Project	IEEE 802.16 Broadband Wireless Access Working Group < http://ieee802.org/16 >	
Title	Changes on Sleep Mode SDLs and MSCs	
Date Submitted	2004-01-15	
Source(s)	Chulsik Yoon, Jaeheung Kim, Kunmin Yeo ETRI 161 Gajeong-Dong, Yuseong-Gu, Daejeon, Korea	Voice: +82-42-860-6826 Fax: +82-42-860-6732 mailto: csyoon@etri.re.kr
Re:	This is a response to a Call for Comments IEEE 802.16e-03/58 on IEEE 802.16e-03/07r5	
Abstract	This document contains suggestions to change the SDLs and MSCs reflecting working groups agreements on the Sleep Mode operation.	
Purpose	The document is submitted for review by 802.16e Working Group members.	
Notice	This document has been prepared to assist IEEE 802.16. It is offered as a basis for discussion and is not binding on the contributing individual(s) or organization(s). The material in this document is subject to change in form and content after further study. The contributor(s) reserve(s) the right to add, amend or withdraw material contained herein.

Changes on Sleep Mode SDLs and MSCs

2. Proposed changes on Sleep Mode operation SDLs and MSCs in IEEE 802.16e-03/07r5

Figure 108h – MSS Awake Mode SDL Diagram

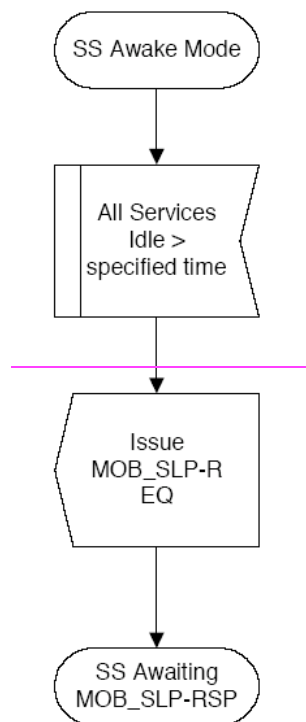
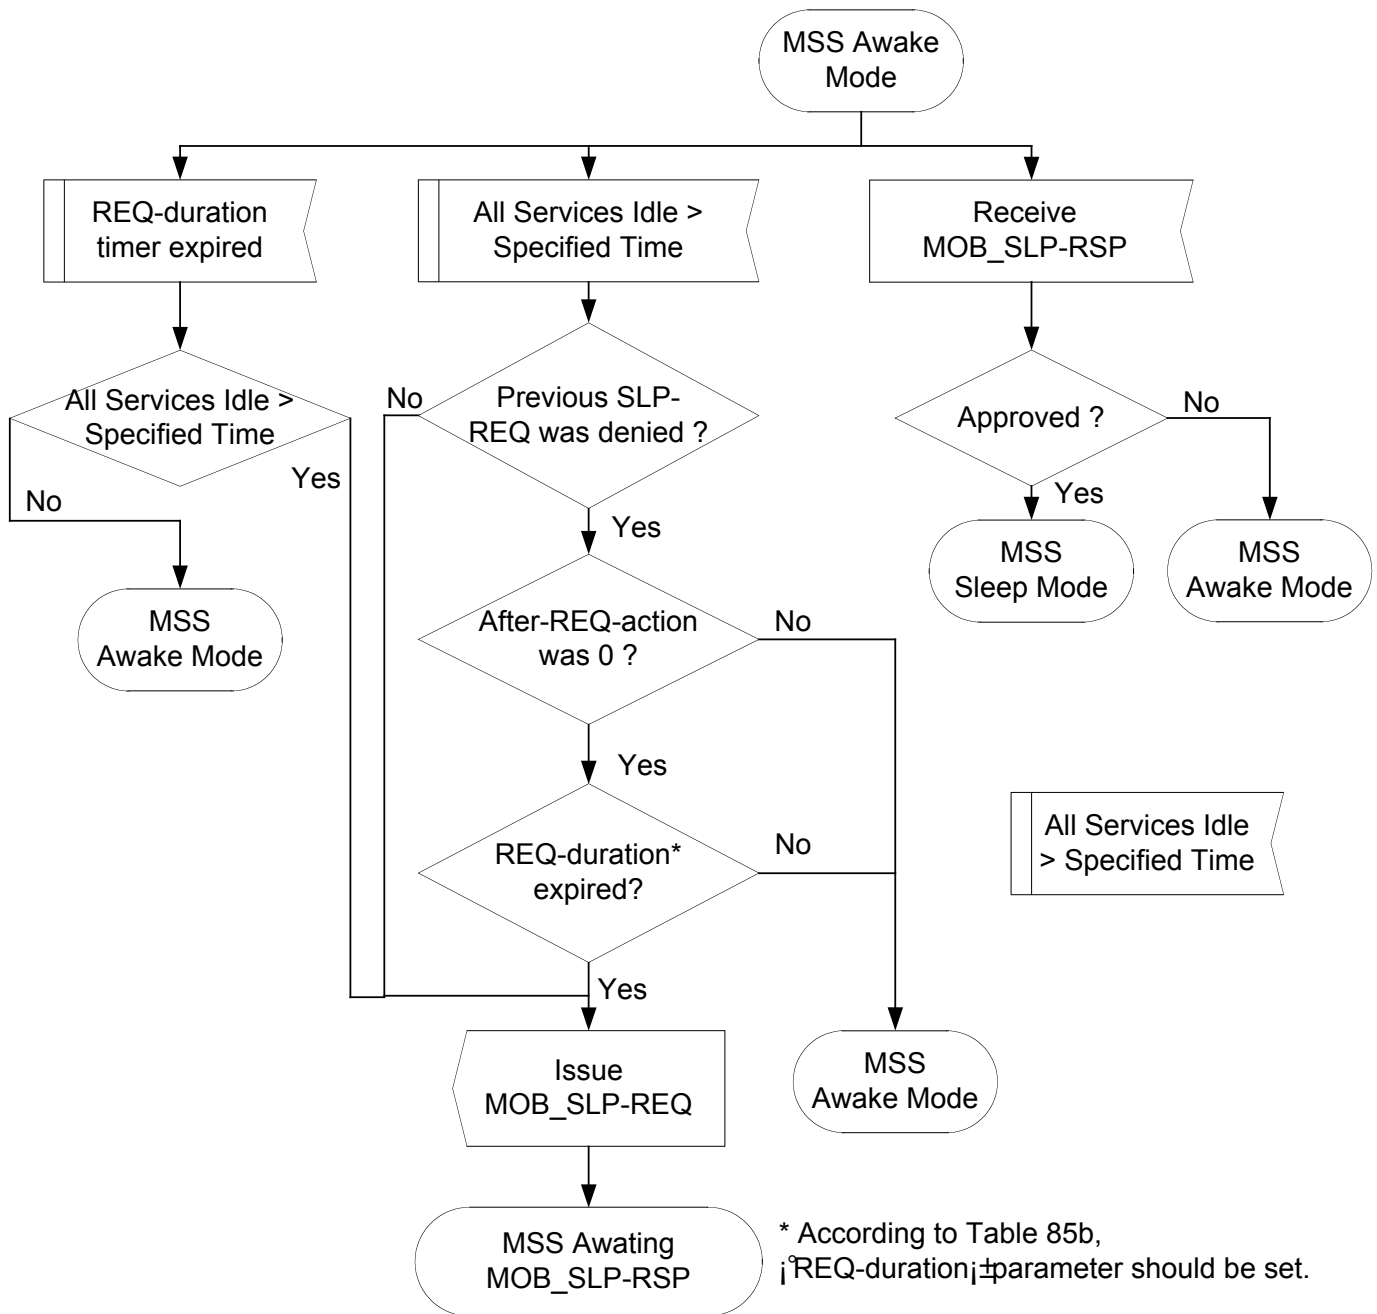
[Replace Figure 108h to the following:]

Figure 108i – MSS Awaiting Sleep Response SDL Diagram

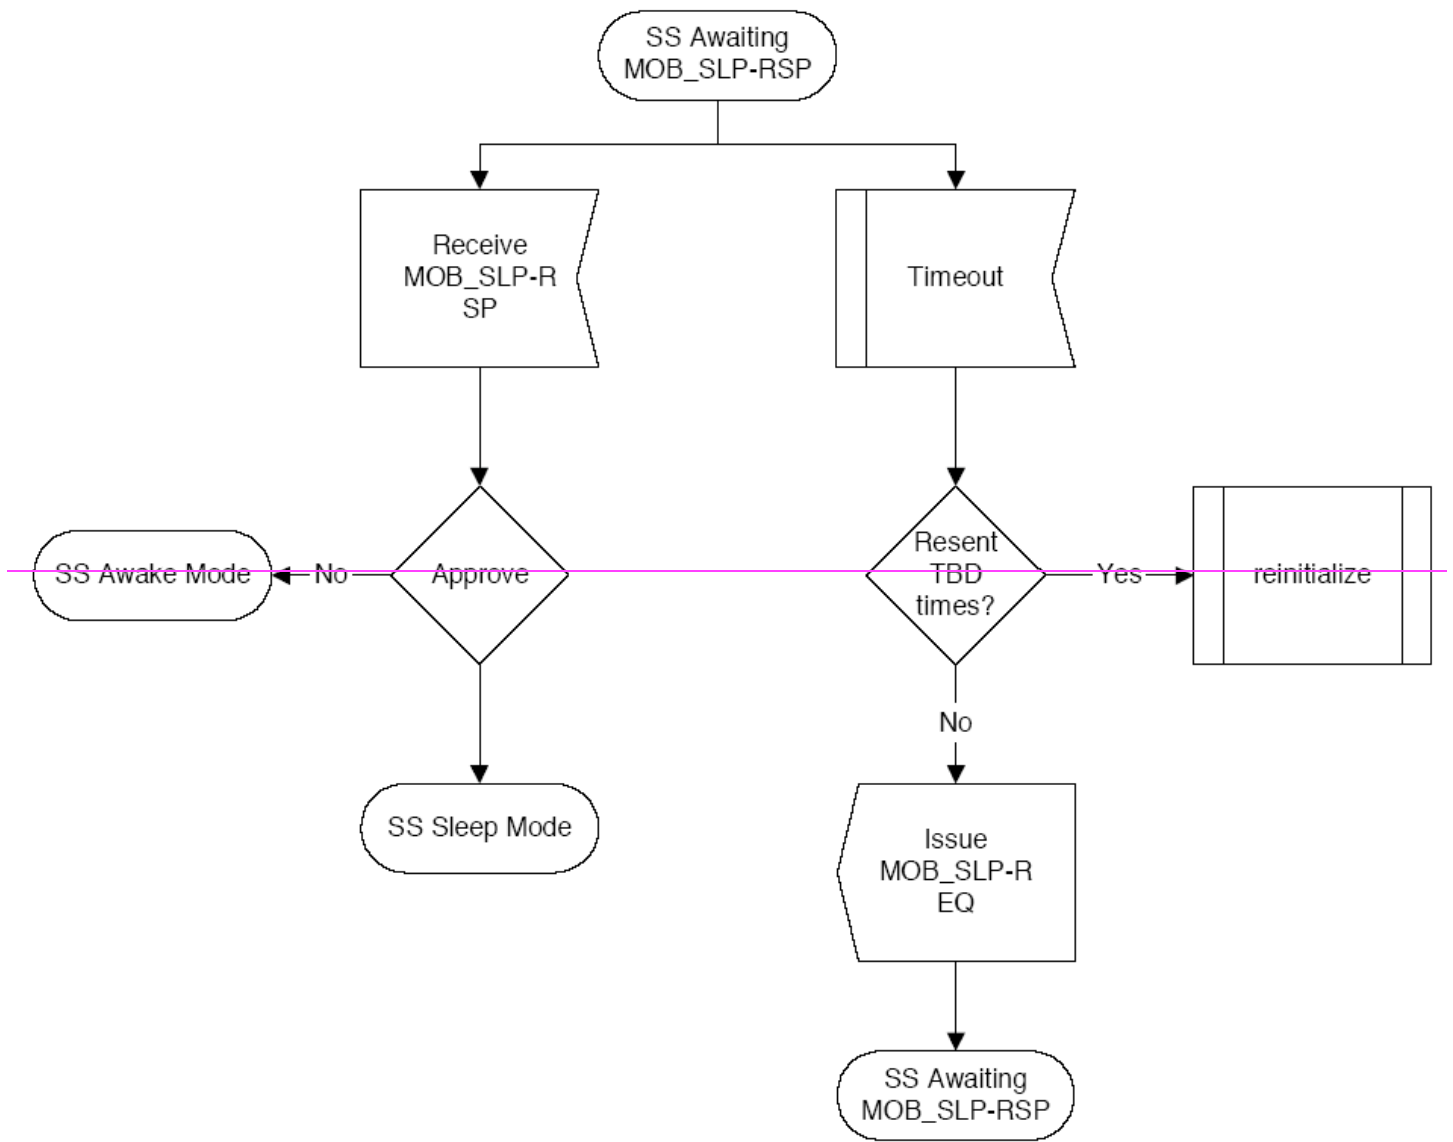
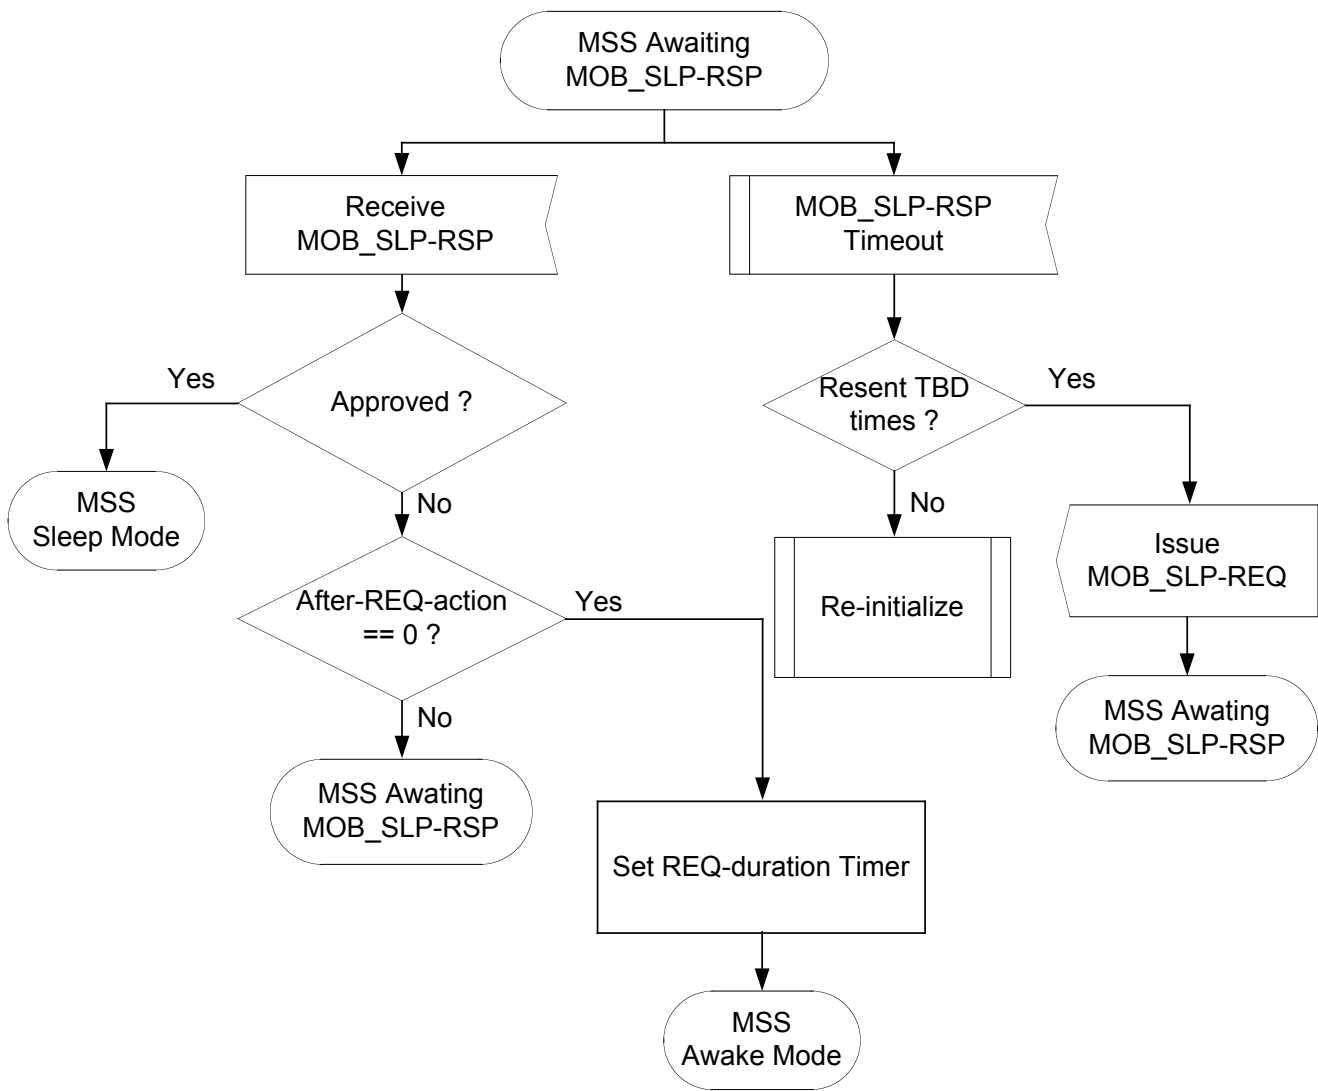
[Replace Figure 108i to the following:]

Figure 108j – Typical MSS Sleep Mode SDL Diagram

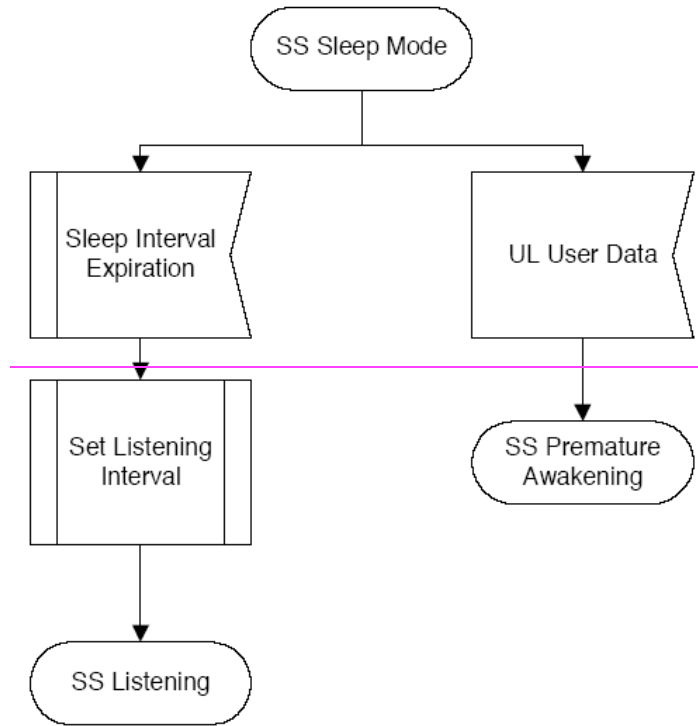
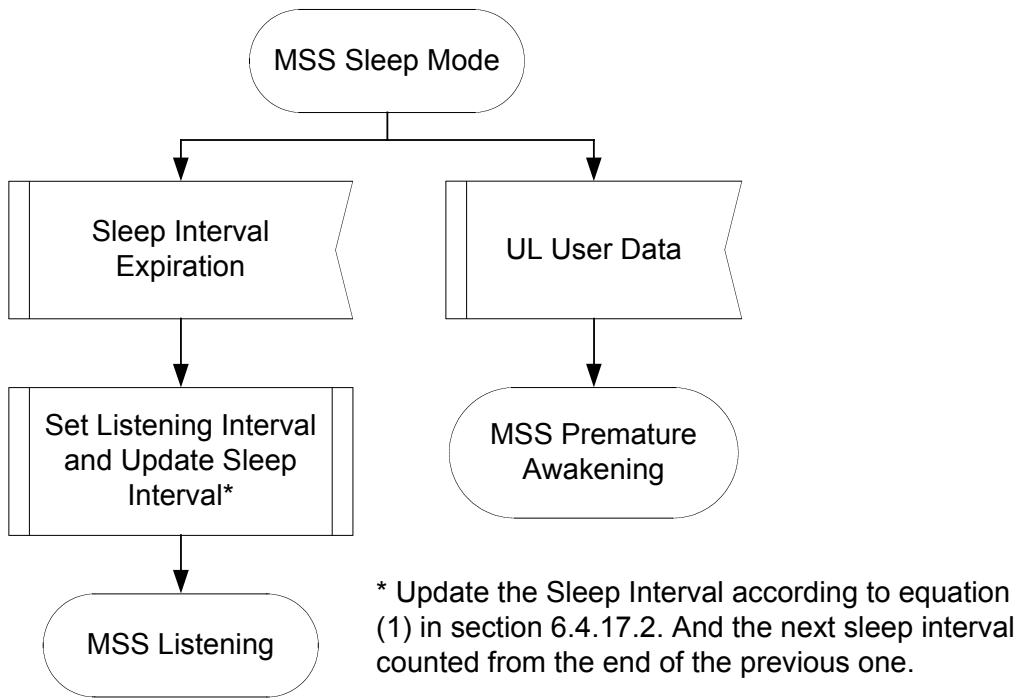
[Replace Figure 108j to the following:]
[From:]

Figure 108k – Typical MSS Listening SDL Diagram

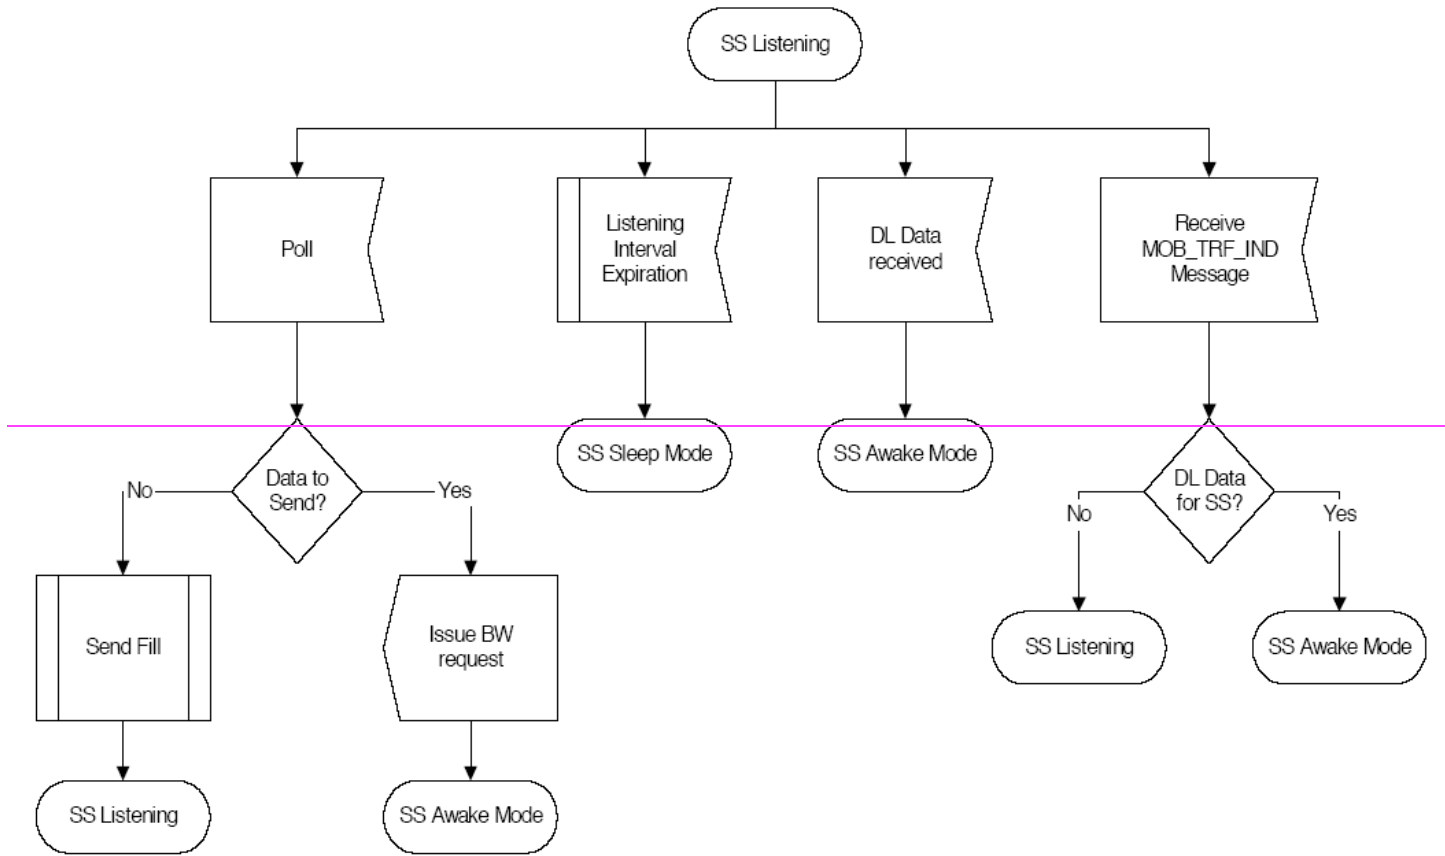
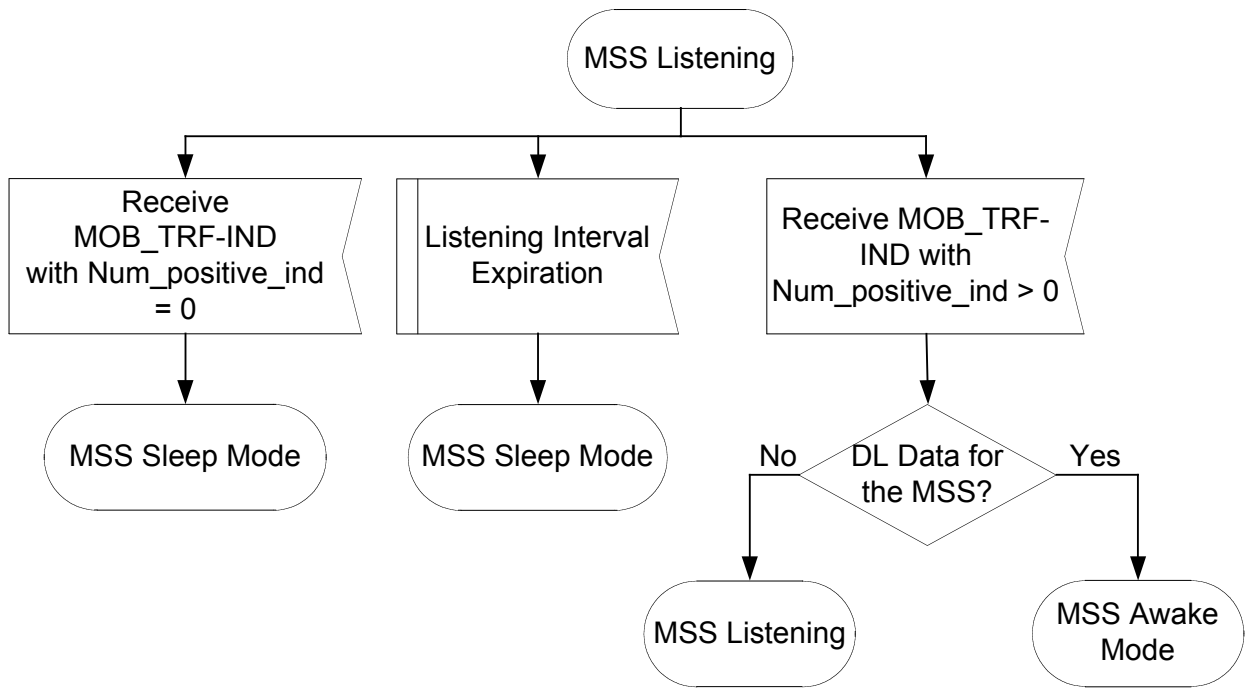
[Replace Figure 106d to the following:]
[From:]

Figure 108I – MSS Premature Awakening SDL Diagram

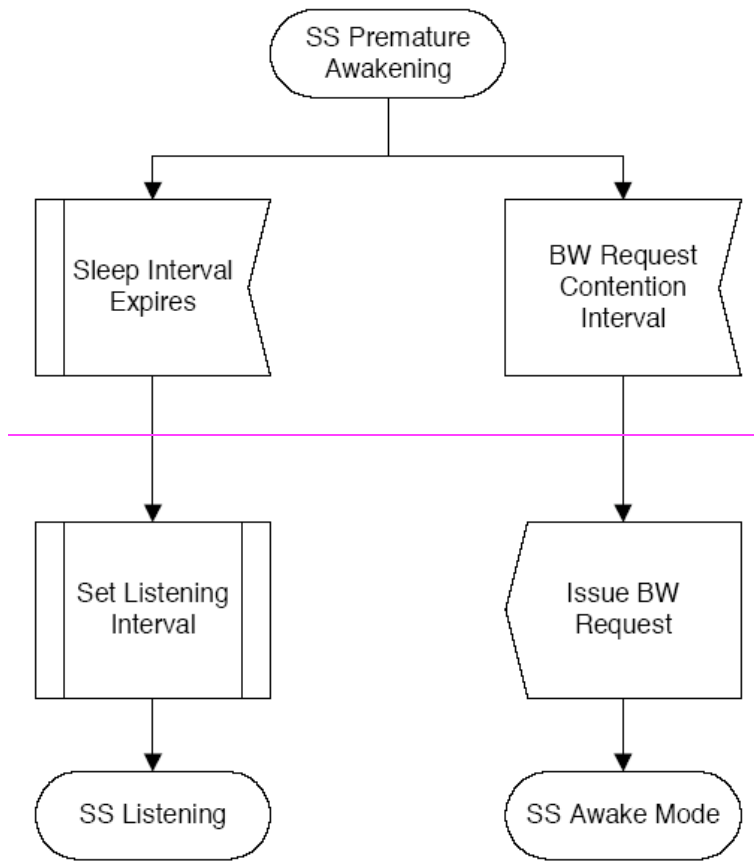
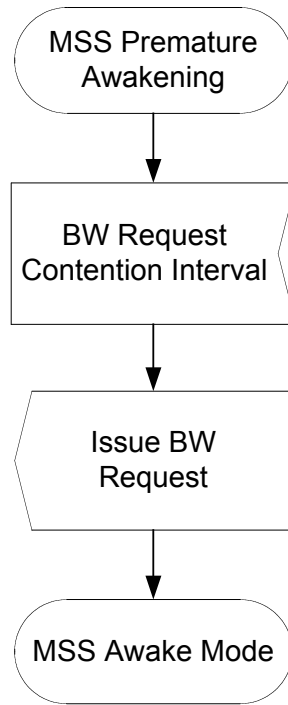
[Replace Figure 108l to the following:]
[From:]

Figure 108m – MSS Premature Awakening SDL Diagram

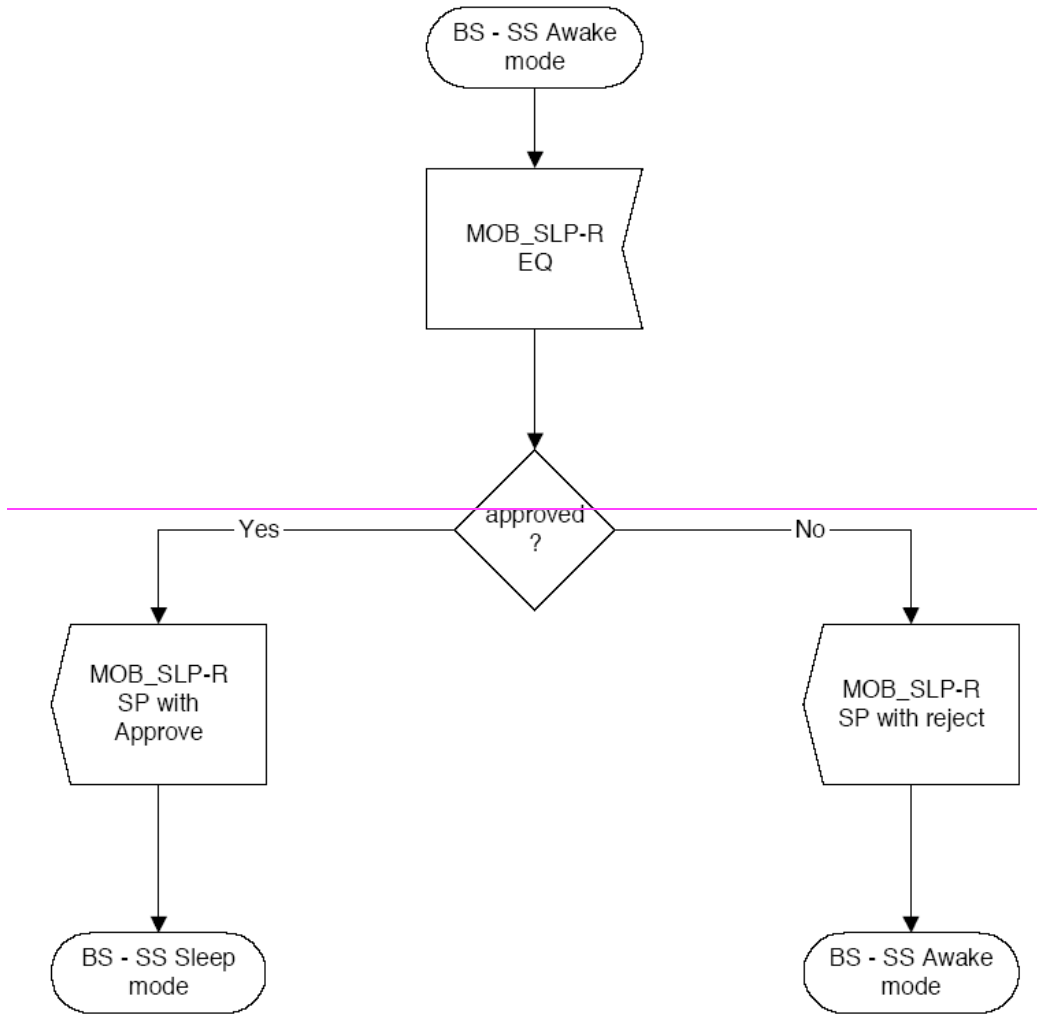
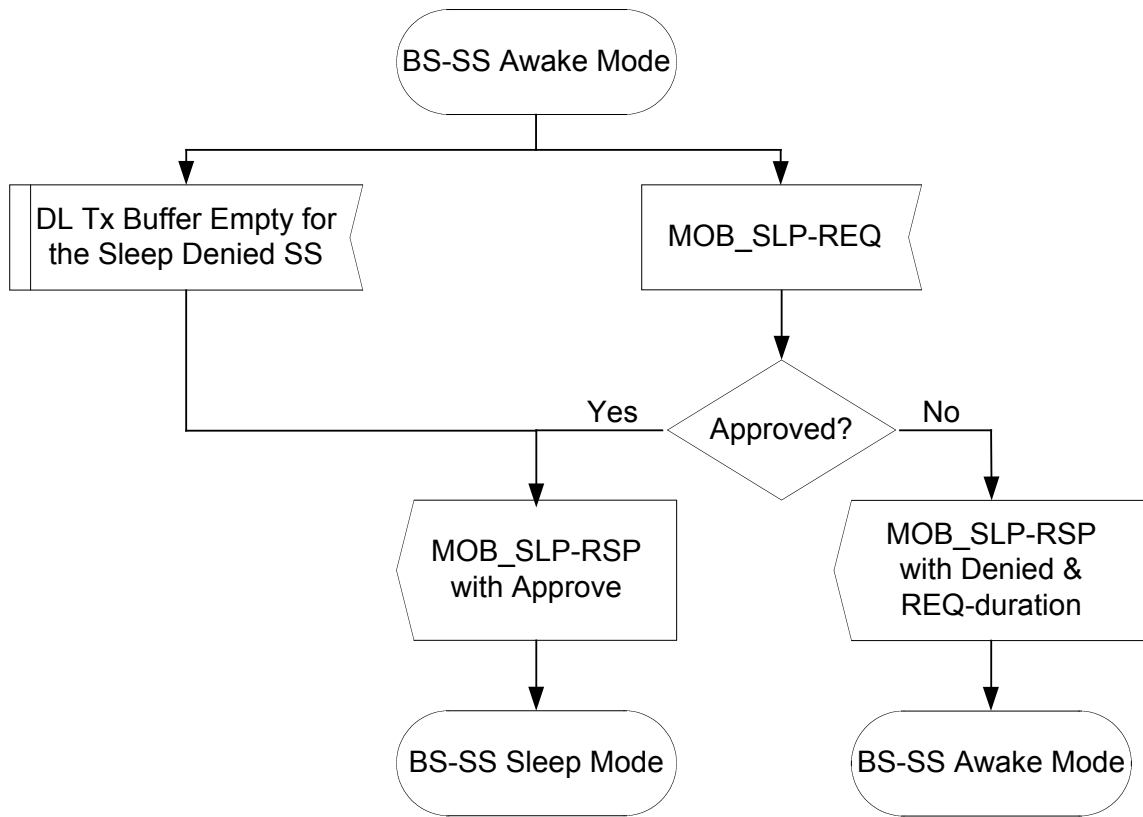
[Replace Figure 108m to the following:]
[From:]
